**LOUDOUN COUNTY, VA
TECHNICAL REVIEW**

**PROPOSED
NEW
138-foot MONOPINE
by
INVISIBLE TOWERS**

Charles Town Pike Site
CMPT 2007-0014
SPEX 2007-0023

November 2, 2007

West View of Proposed Tower

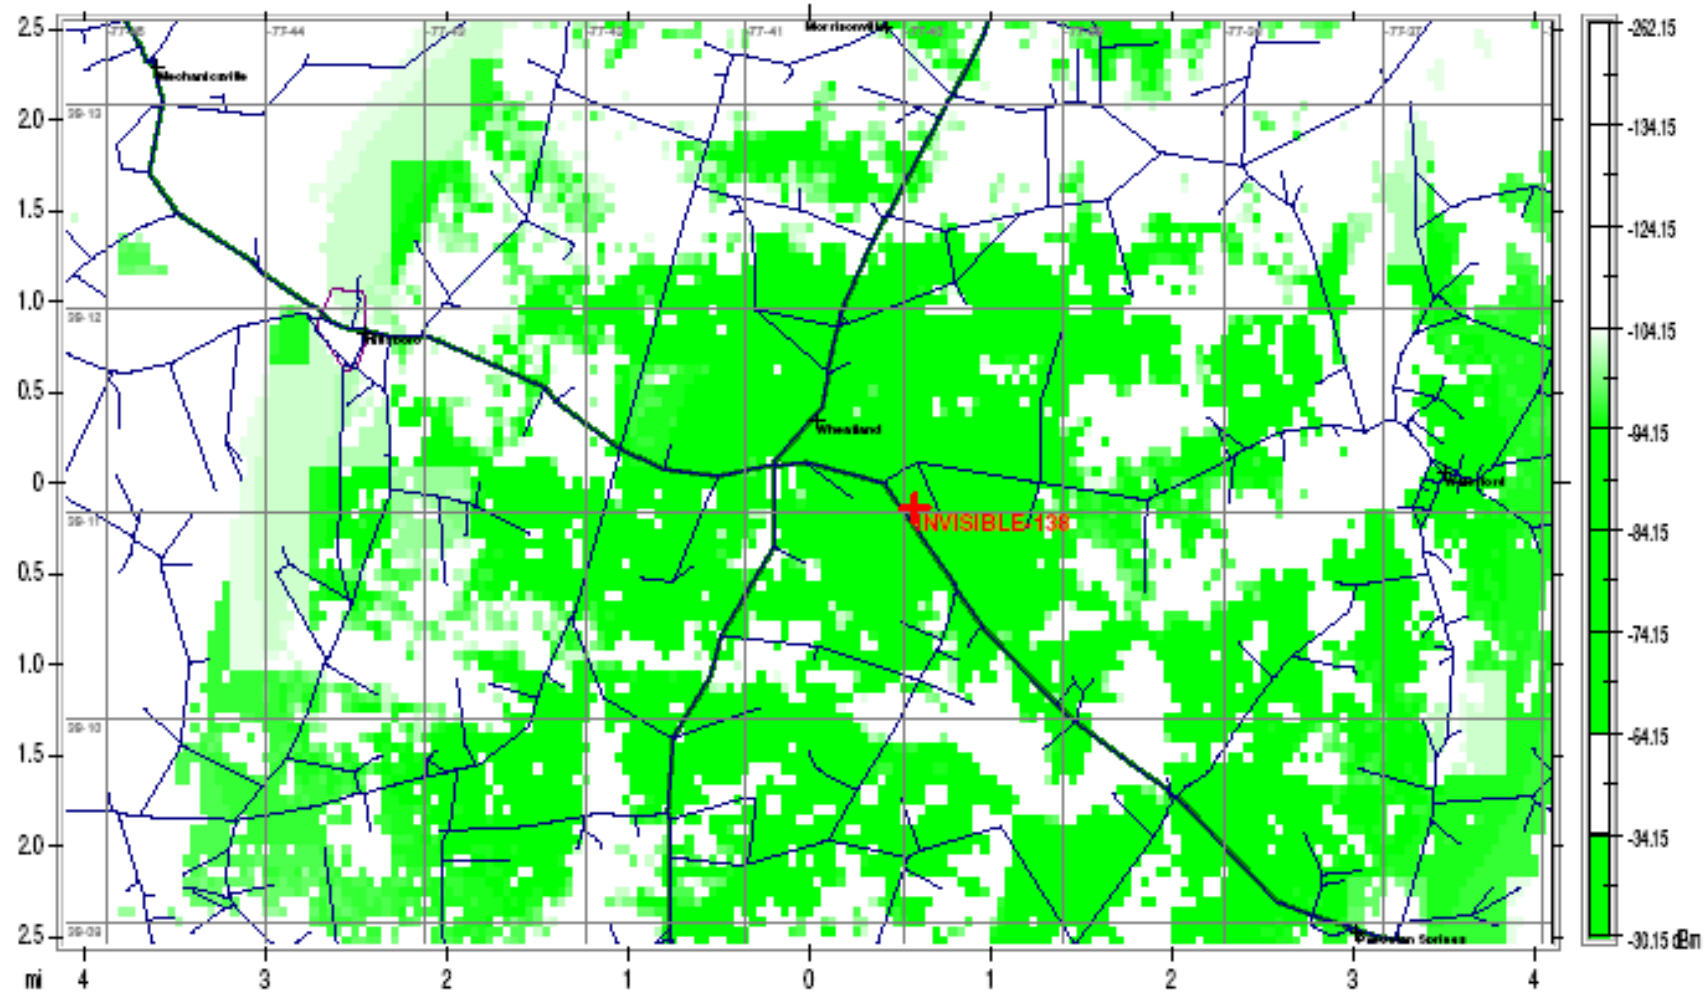
Approximate location in backyard of residence @ 195' from House

Residence of Property Owner

Mature Trees of hardwood variety of approximately 70' AGL.

Agricultural location in nearby area that has wooded area not in conflict with residential use.

Notice residential structure of adjacent property owner.
